SUBJECT: Service Instruction M20-88A - STABILIZER TRIM STOP/SCREW MODIFICATION
Dated 12/14/2016.

SERVICE INSTRUCTION M20-88A
Date: December 14, 2016

SUBJECT: STABILIZER TRIM STOP/SCREW MODIFICATION

INTRODUCTION: This Revision Supersedes M20-88 Dated 5/1/1990

Figure SI M20-88-1

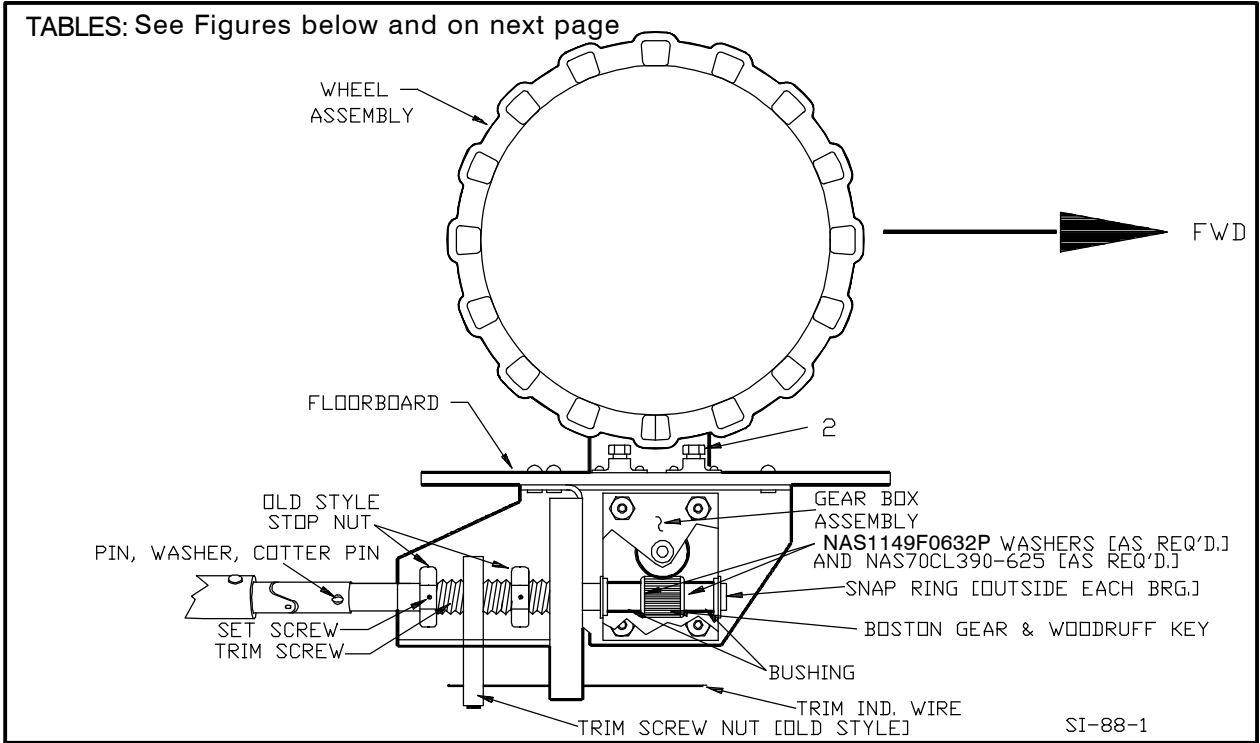
4. Remove cotter pin, washer and pin that secures trim tube universal joint to trim screw (Figure SI M20-88-1).
5. Loosen gear box bolts (Index 1, Figure SI M20-88-2) if not already done, and both NAS428-3-4 bolts (Index 2, Figure SI M20-88-2) to give slack in roller chain between upper and lower sprocket of trim control wheel assembly.

7. Remove roll pin, P/N RPA52-028-125-1125 holding lower sprocket, P/N 740049, to gear box shaft. Remove sprocket.
8. Loosen set screw, #6-32 x 1/8, in each existing trim stop so they will unscrew easily. Remove aft trim stop (DN stop) from trim screw (Fig. SI M20-88-1).

12. Measure and document longitudinal free play in trim screw shaft (end play) as assembled in the gear box assembly.
13. Remove forward snap ring from trim screw. Reference Figure SI M20-88-1
14. Lightly tap trim screw at forward end, with a plastic mallet, to drive trim screw, bushings, washers, gear and aft bearing from gear box assembly housing. Bearings are installed with loctite (Blue) at assembly, so some effort may be required to break it loose. **DO NOT DAMAGE BEARING OR HEATING THE HOUSING.**
15. When existing trim screw, and components attached to it, comes free from gear box housing, the bushings, washers, gears, woodruff key, snap ring and aft bearing will be removed. Retain components, except woodruff key, to place back on new trim screw (Fig. SI M20-88-1).

16. Install existing snap ring, P/N NAS51-37 on mid groove of new trim screw, P/N 740016-019. Re-assemble shim(s), bearing, bushing, washer(s), Boston gear, new woodruff key, washer(s) and spacer on new trim screw.

Figure SI M20-88-2

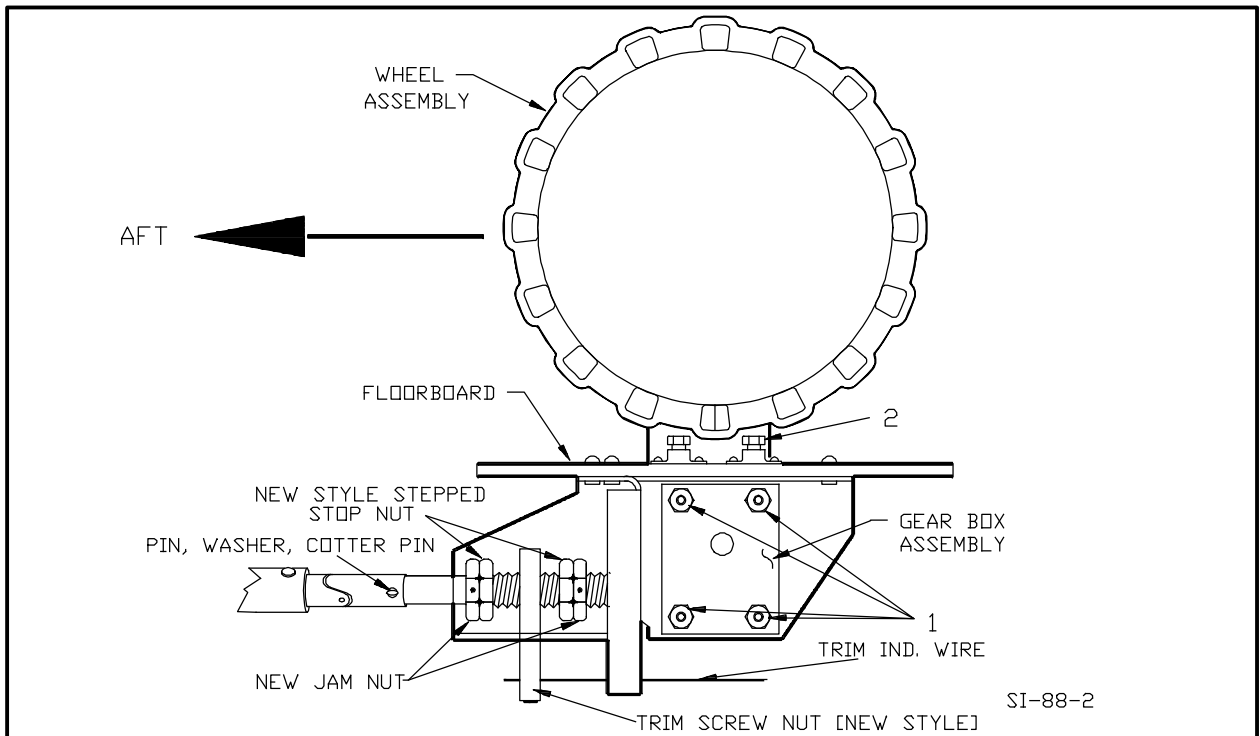
1. Remove belly access panels or smooth belly fairing to gain access to lower side of the trim control wheel assembly.
2. Remove trim indicator wire from trim screw nut by loosening set screw(s) that restrain trim wire.
3. Remove any brackets connected to gear box bolts (Index 1, Figure SI M20-88-2) both sides if required. Different models have different type of brackets.

22. Install one jam nut (UP stop side), P/N 740086-003 (M20J) or 740086-001 (M20K, M20L or M20M), on trim screw. Screw toward gear box housing leaving approximately 0.375 inch gap on threads between gear box and jam nut (Figure SI M20-88-2).
23. Install one stepped stop nut (UP stop), P/N 740086-007 (M20J) or 740086-005 (M20K, M20L or M20M) on trim screw. Screw toward gear box housing and against jam nut installed in step 22.

The stepped portion of stop nut must be facing away from gear box housing.

24. Position gear box/trim screw assembly to lower trim wheel assembly so new trim indicator nut, P/N 740086-011 (M20J) or 740086-009 (M20K, M20L or M20M) can be placed on trim screw and screwed in place to proper position within slotted bracket area. This is the reverse of Steps 9 & 10.
25. Install other stepped stop nut (DN stop) (stepped side toward trim indicator nut) on trim screw.
26. Install other jam nut on trim screw against stop nut (DN stop).
27. Reverse Steps 2 thru 7 to reposition gear box assembly back on trim wheel assembly. Do not tighten trim indicator wire set screw at this time. Position all other brackets but do not tighten bolts holding gear box assembly to trim wheel assembly (Fig. SI M20-88-2).
